**Pleasanton Road Water Main Replacement at Hume Road**  
**Solicitation Number: CO-00221**  
**Job No.: 18-4004**

**ADDENDUM 2**  
**October 31, 2018**

TITLE: WATER PIPE TRENCH DETAILS

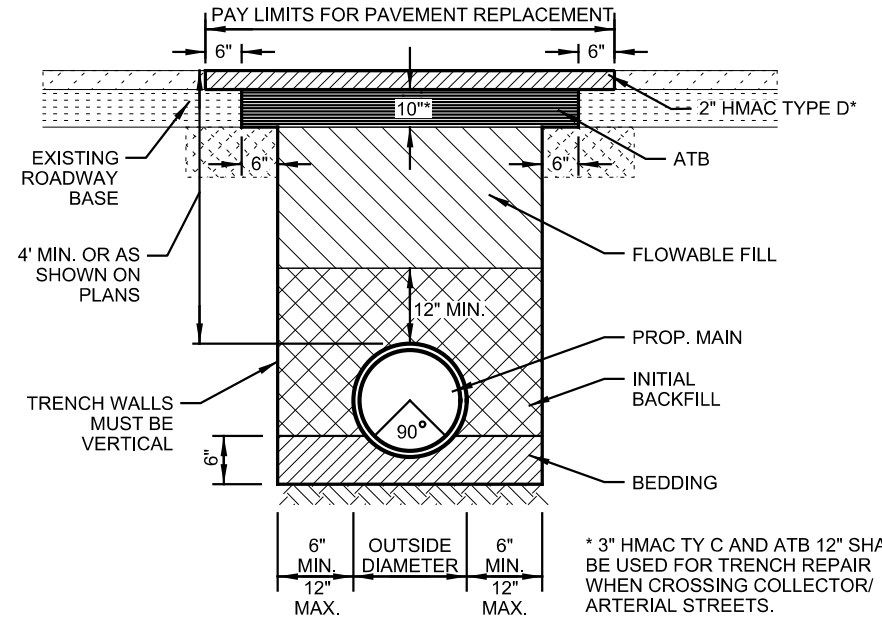
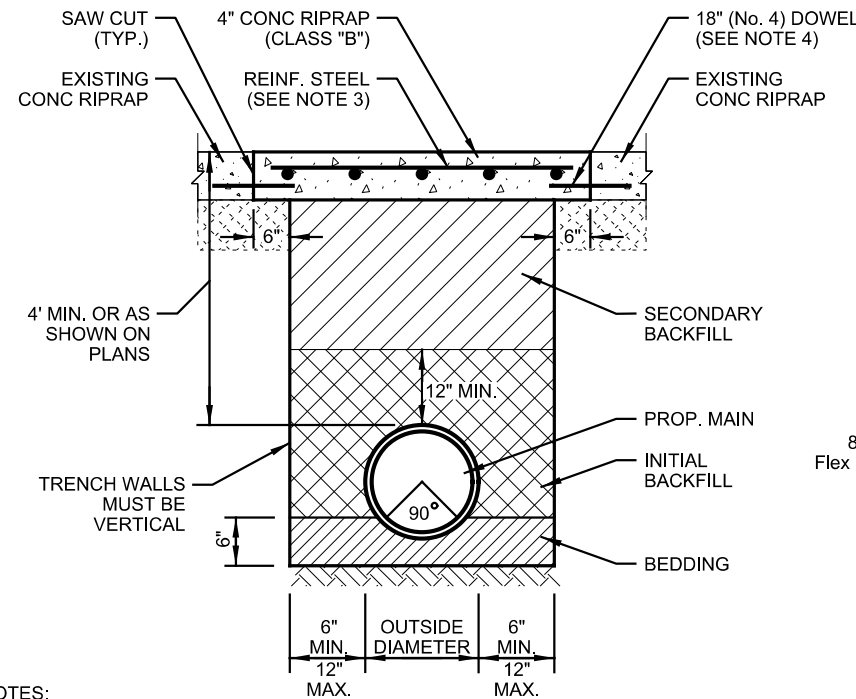
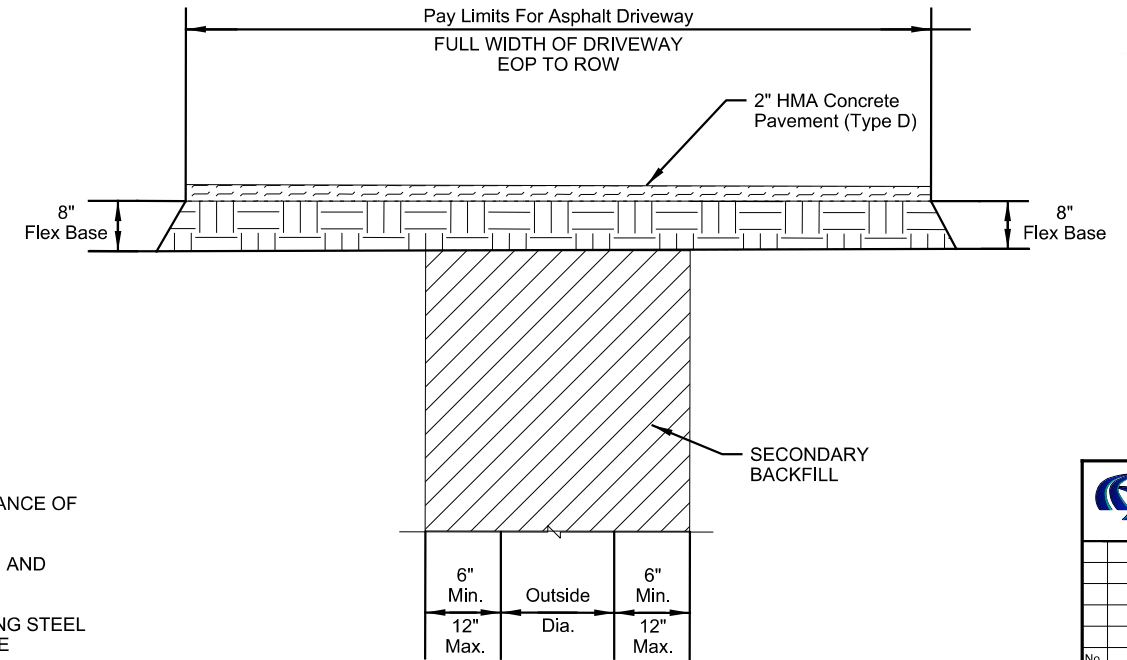
- 5. Is the intent on Bid Item No. 9 "Asphalt Concrete Driveway" that this item consist of 2" Hot Mix Type D only? Will the base underneath it be paid for under Bid Item No. 5 or Bid Item No. 10?**  
*Asphalt concrete driveway shall be bid as shown on Water Pipe Trench Details attached to this addendum. The base for the Bid Item No. 9 shall be paid for under Bid Item No. 9 "Asphalt Concrete Driveways".*

1. **Remove Water Pipe Trench Details page 51 of 63 in its entirety and replace with the revised page. This version should be used when submitting a bid for this project.**
